2. Item 1A

Appeal of Planning Commission Resolution No. 26-05 Regarding Coastal Development Permit No. 19-012 (25200 Pacific Coast Highway, APNs 4459-013-021 and 4459-014-018; Owner, PAR PCH, LLC; Appellant, Jun Hall for Concerned Citizens of Malibu Road, Inc.)

Amended[1] Malibu City Council
Special Meeting Agenda

Proposed Guest House

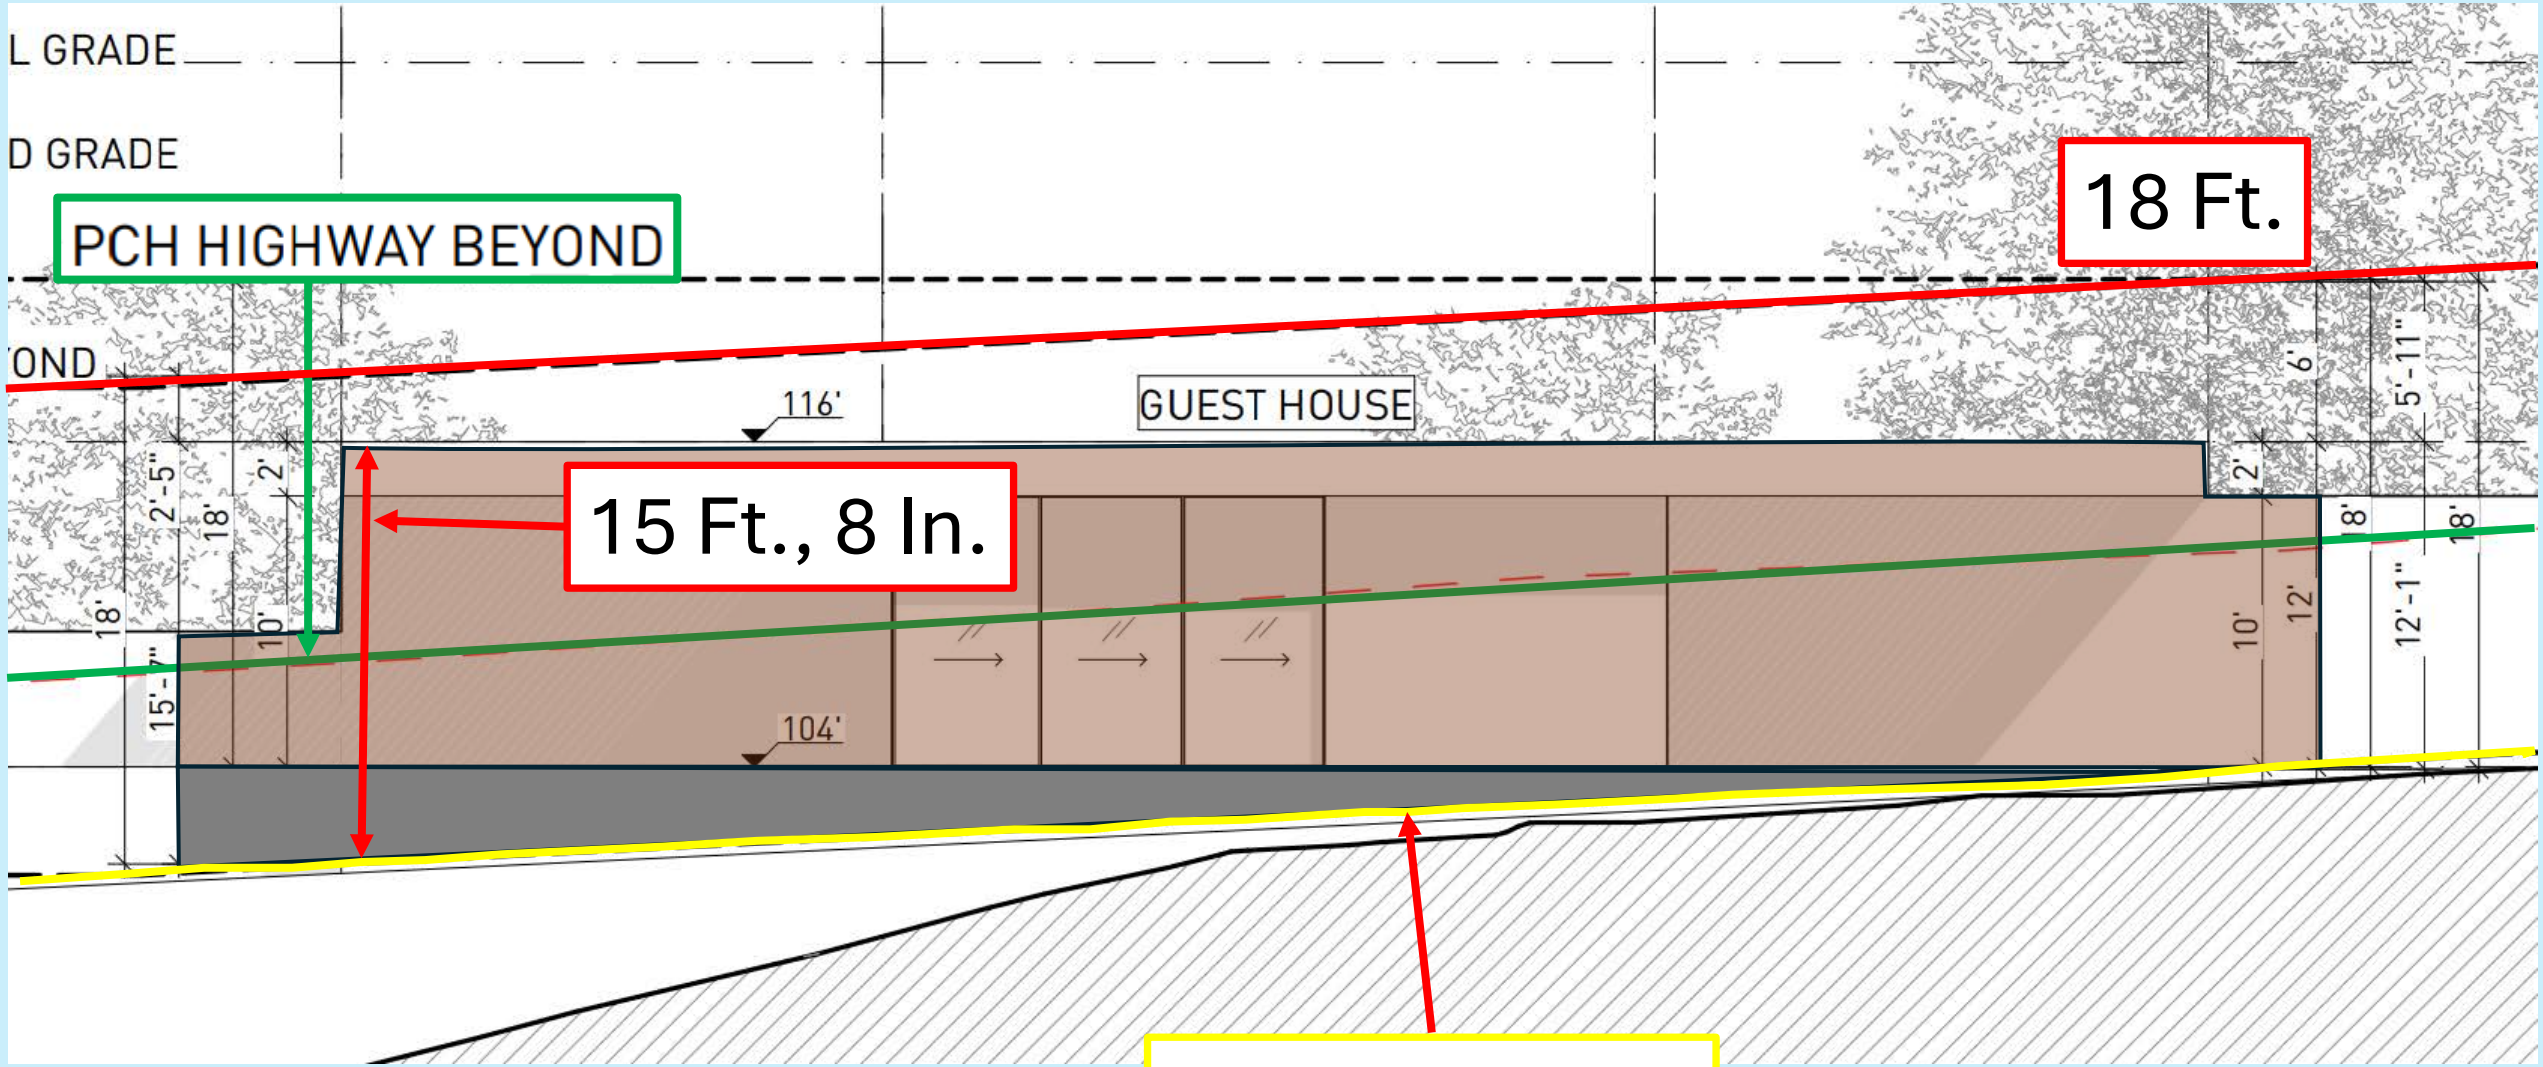
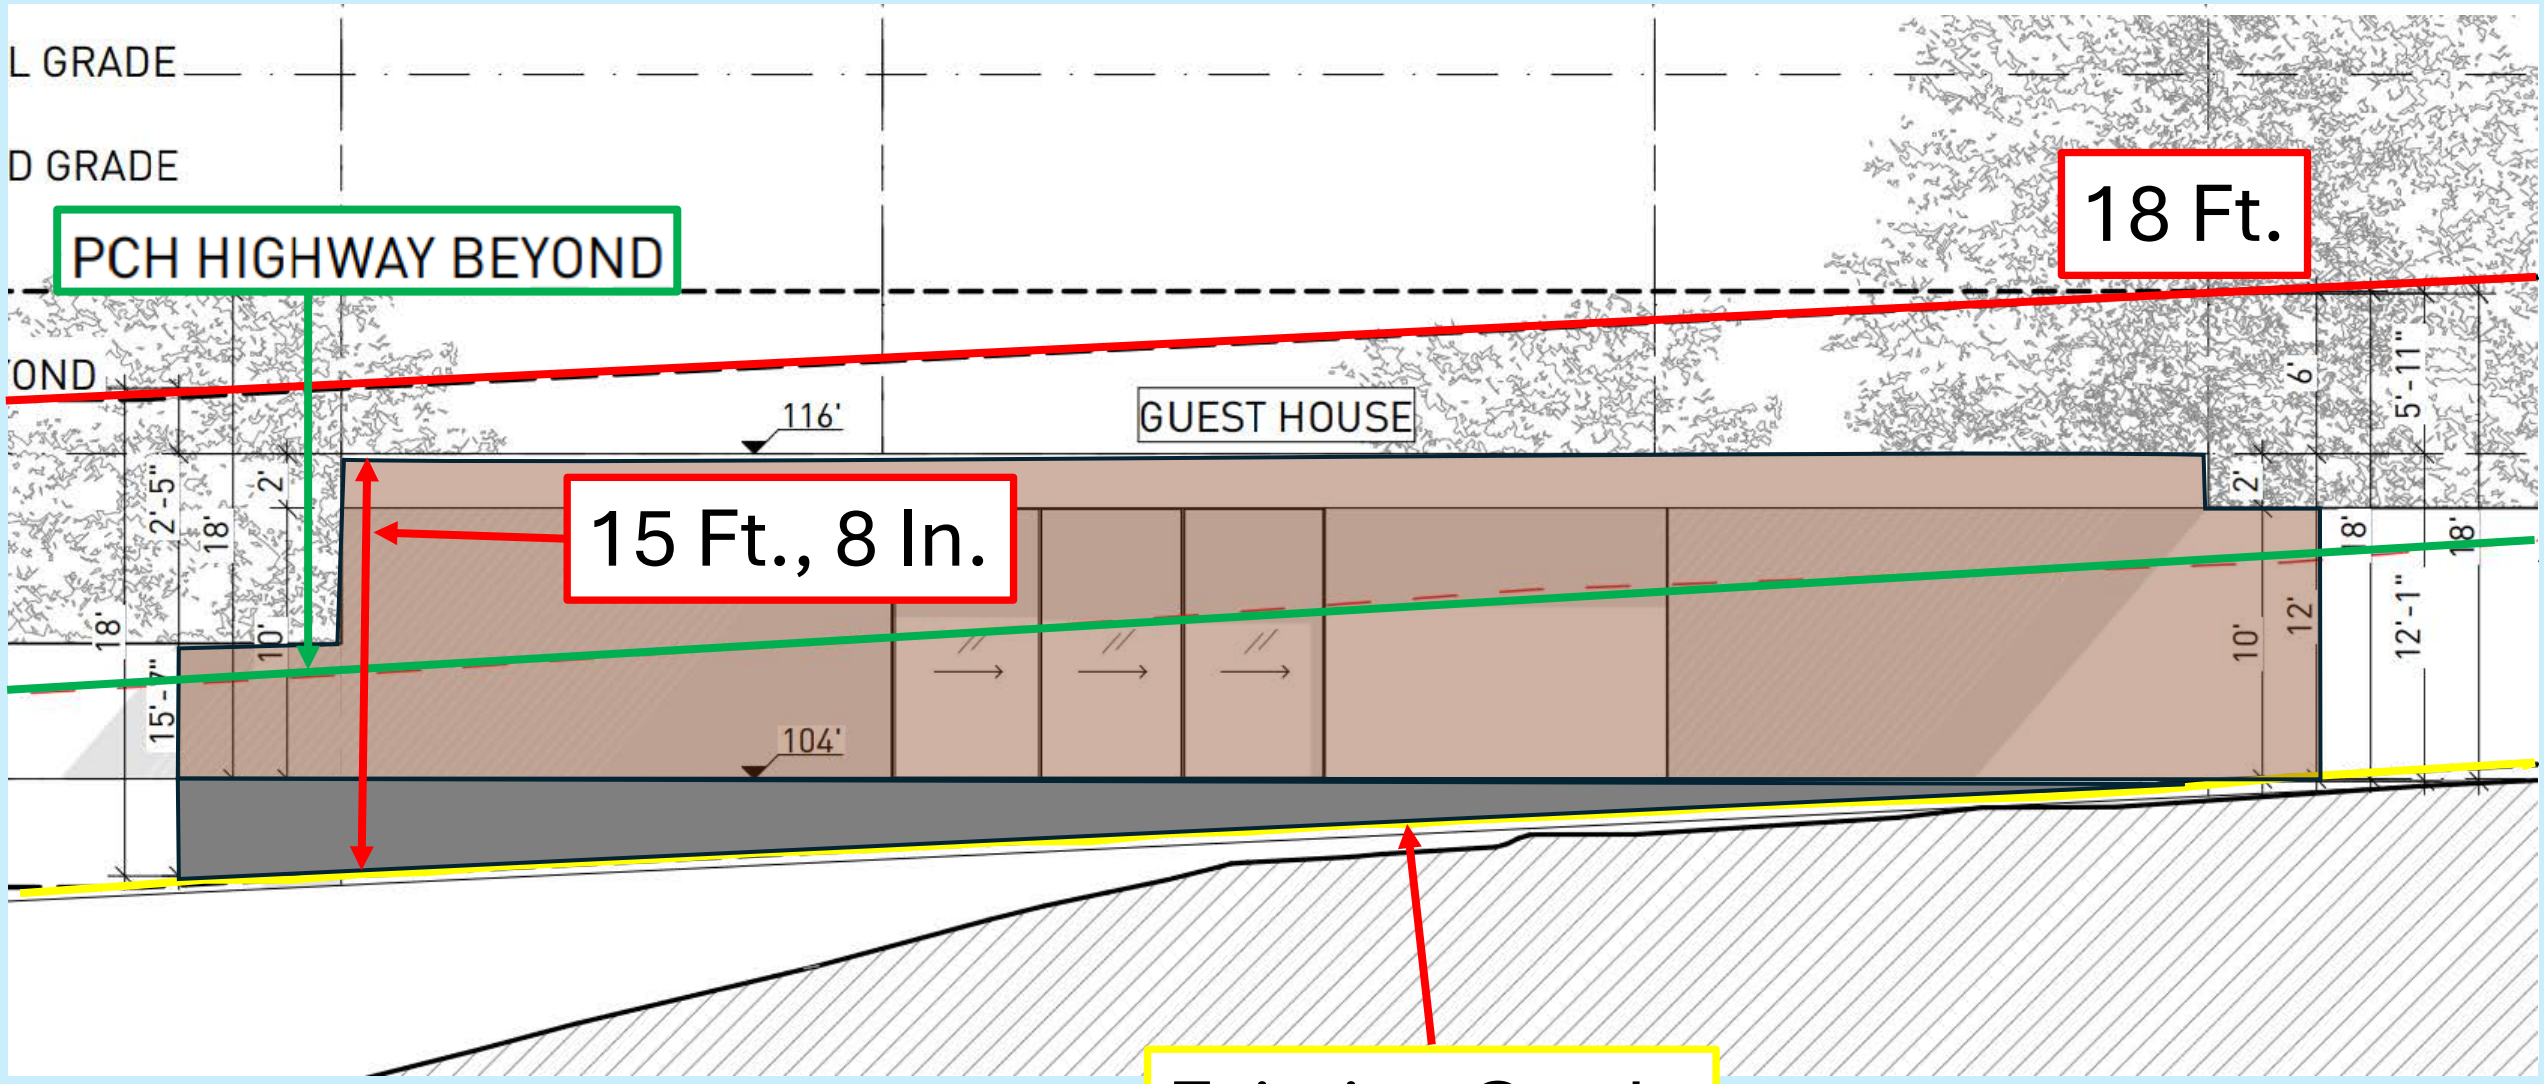
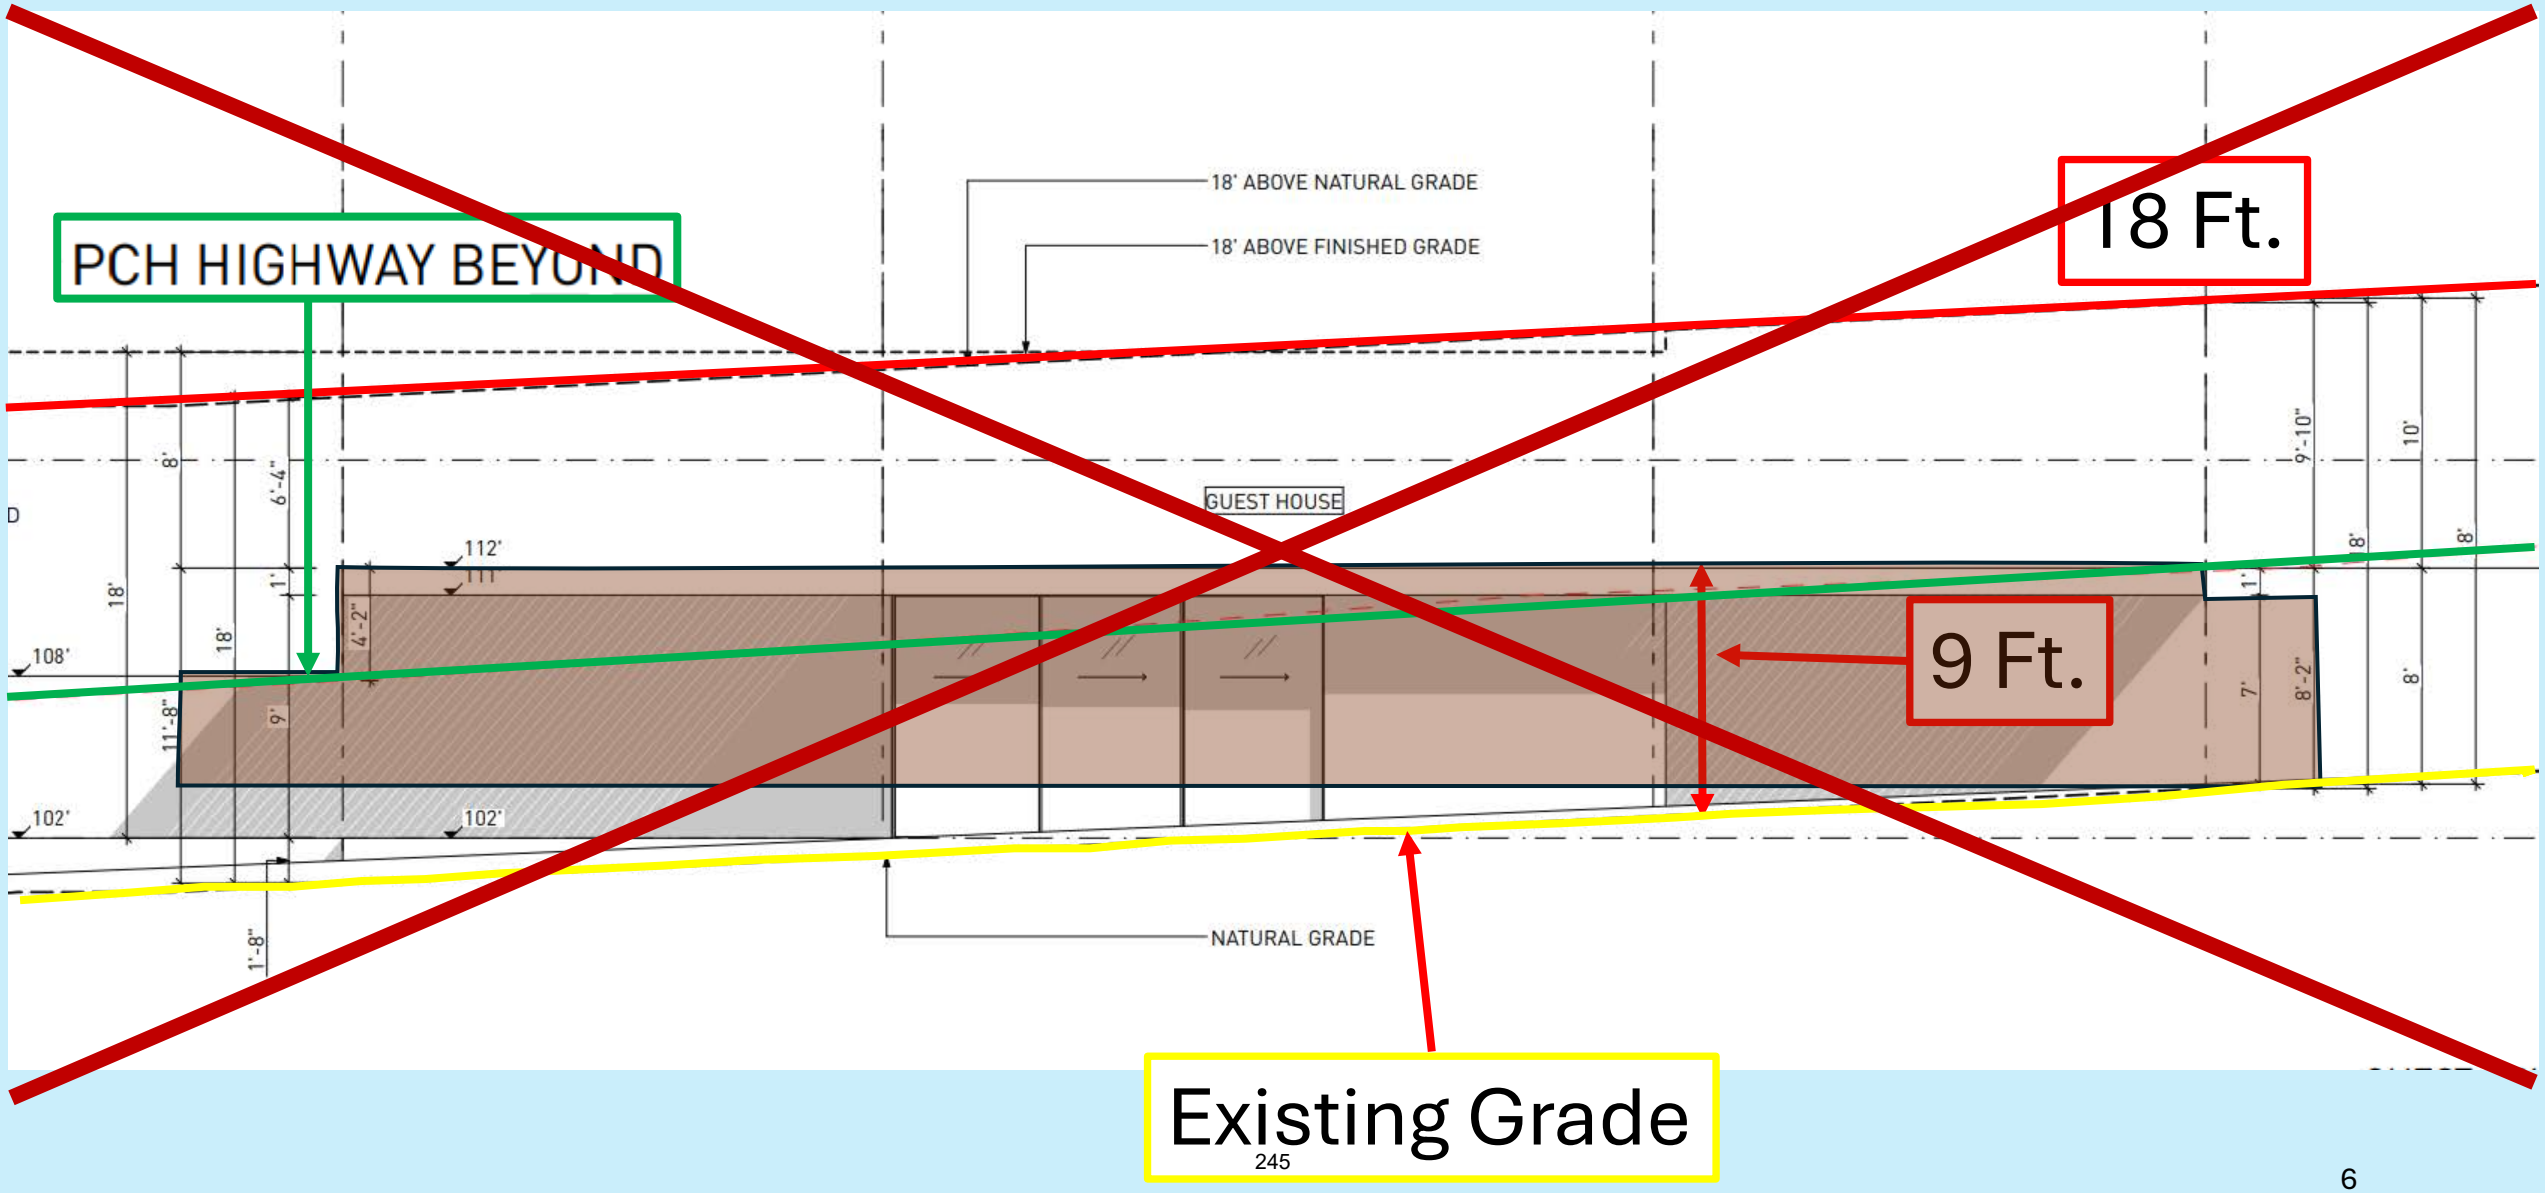
Guest House Height Originally 15 Feet, 8 Inches

Guest House No Longer Part of Application
